ASOS MODIFICATION NOTE 35 (for Electronics Technicians)

SUBJECT : Upgrade to the ASOS Heating Tipping Bucket

PURPOSE : To add operational enhancements for the ASOS Heating

FIGURE 1

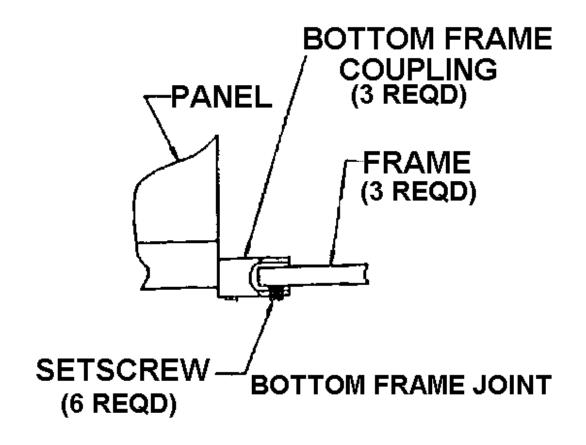
- 1. At the lower end of the wind skirt assembly remove one of the existing devices.
- 2. Reference attached drawing figure 1, and replace the removed assembly with a wind skirt attachment device P/N 2125 00201.
- 3. Repeat the process until all three existing attachment devices on the lower ring of the wind skirt are replaced.
- 4. This completes the Installation of wind skirt attachment devices.
